Client: New Homes, Inc.
Project: Smithfield - French Country GR
Address: 4524 Duncan Creek Road
Lillington, NC - 27546

Date: 4/22/2025
Input by: Hampton Horrocks
Job Name: 156 Duncan's Creek - 1st Floor EWP
Project #: J1024-5460

**FJ28-rear BLI 40 11.875" - No Repair Required
See User Note 1**

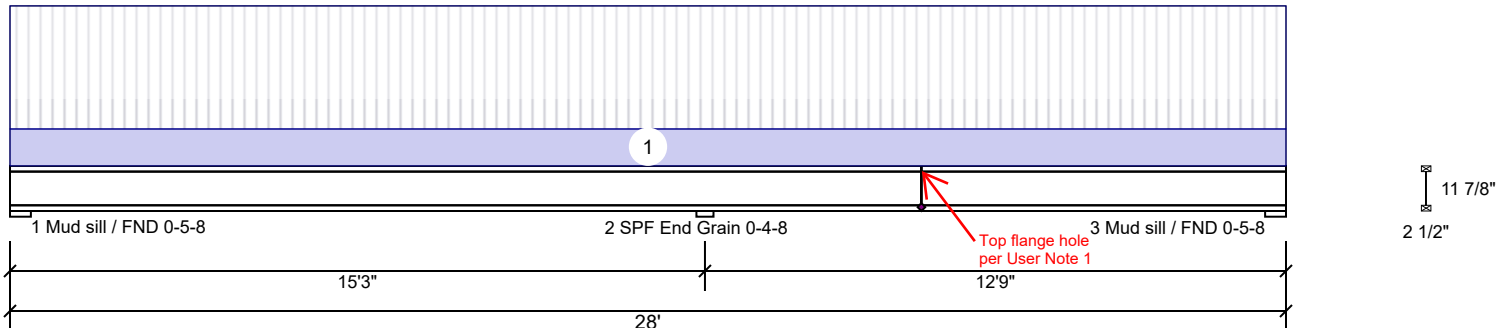
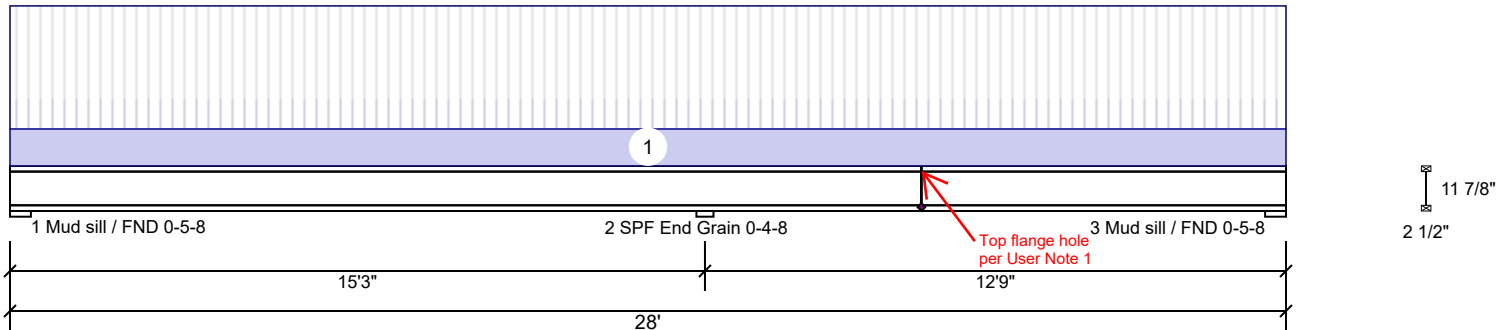
- Location Analysis represents ~1/2" diameter vertical hole going through one side of top flange. Hole is located against web, but does not appear to intrude into the web. This design based on scaling of provided photograph. No definitive cross-section dimensions of vertical top flange hole were provided. Stated cross-section dimensions of damage depicted in this calculation should be field-verified. No repair required.

FJ28-front BLI 40 11.875" - Repair Required
See User Notes 1-4

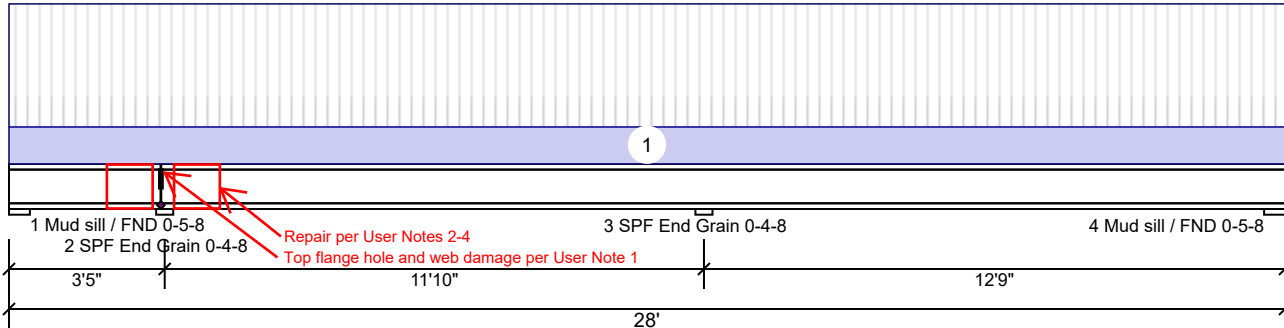
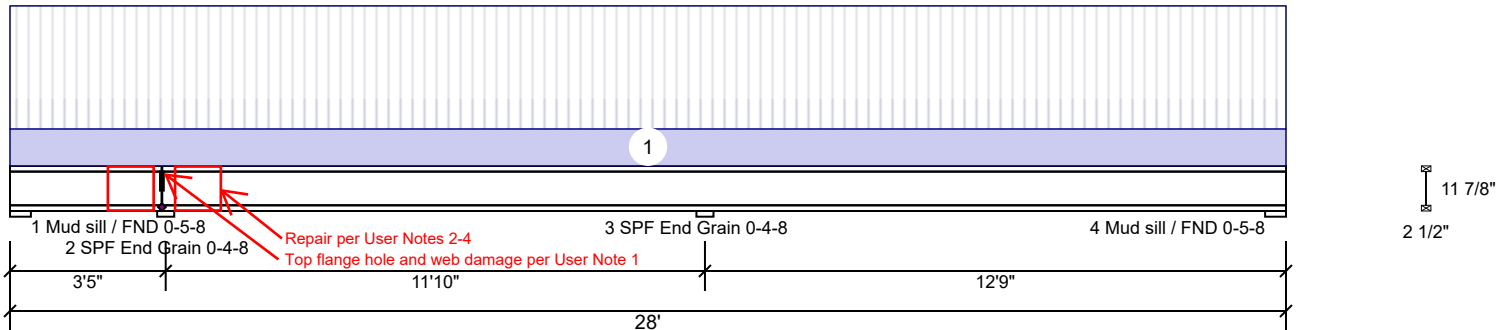
- 1 Location Analysis represents ~1/2" diameter vertical hole going through one side of top flange. Hole is located against web. Web appears to be damaged below vertical hole as indicated in Hole Analysis table. This design based on scaling of provided photograph. No definitive cross-section dimensions of vertical top flange hole were provided. Stated cross-section dimensions of damage depicted in this calculation should be field-verified. Repair as follows.

- 2 Attach 23/32" x 11 7/8" high x 12" long APA 48/24 span-rated plywood (face grain horizontal) to top & bottom flanges on one face with 8d Sinker Nails (0.113 x 2 3/8") @ 3" o.c.
- 3 Use 1/4" bead of carpenter's wood glue on all contact surfaces.
- 4 Locate at both vertical edges of perpendicular blocking.

FJ16 BLI 40 11.875" - No Repair Required
See User Note 1

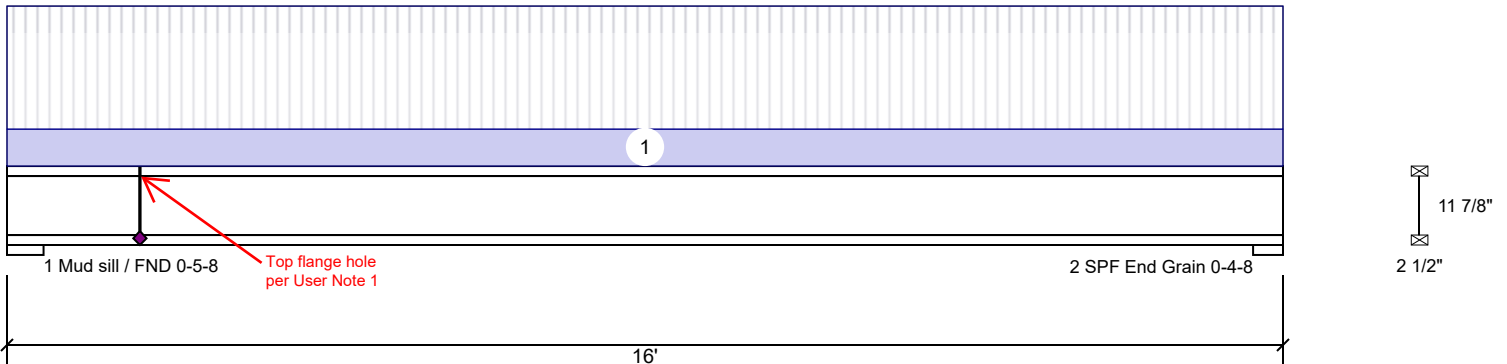
- Location Analysis represents ~1/2" diameter vertical hole going through one side of top flange. Hole is located against web, but does not appear to intrude into the web. This design based on scaling of provided photograph. No definitive cross-section dimensions of vertical top flange hole were provided. Stated cross-section dimensions of damage depicted in this calculation should be field-verified. No repair required.

FJ9 BLI 40 11.875" - Repair Required See User Notes 1-4

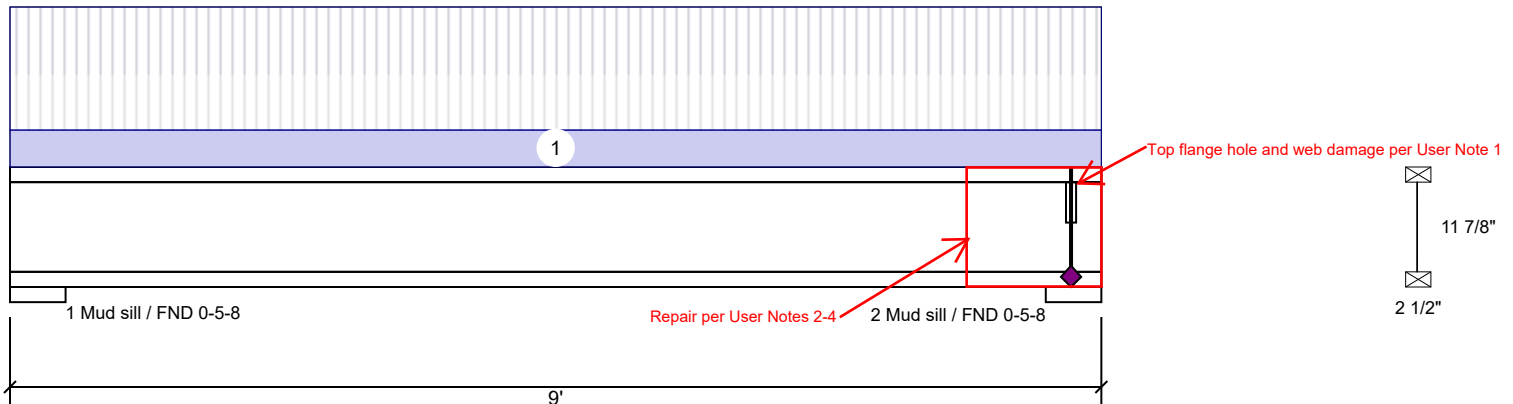
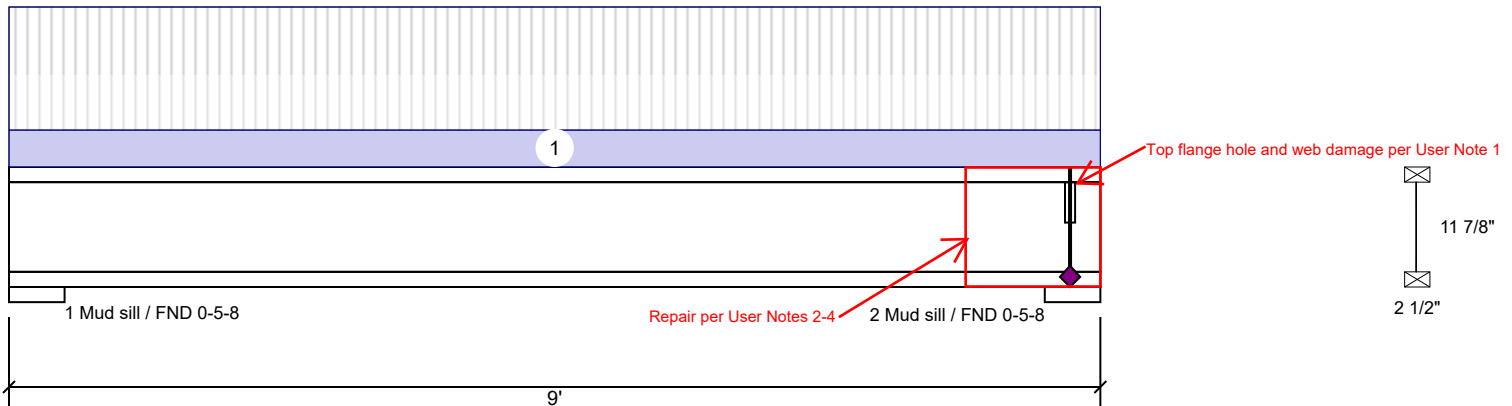
- 1 Location Analysis represents ~1/2" diameter vertical hole going through one side of top flange. Hole is located against web. Web appears to be damaged below vertical hole as indicated in Hole Analysis table. This design based on scaling of provided photograph. No definitive cross-section dimensions of vertical top flange hole were provided. Stated cross-section dimensions of damage depicted in this calculation should be field-verified. Repair as follows.
- 2 Attach 23/32" x 14" high x 12" long APA 48/24 span-rated plywood (face grain horizontal) to top & bottom flanges on opposite face from web damage with 8d Sinker Nails (0.113 x 2 3/8") @ 3" o.c.
- 3 Use 1/4" bead of carpenter's wood glue on all contact surfaces.
- 4 Locate end of gusset at right end of joist.
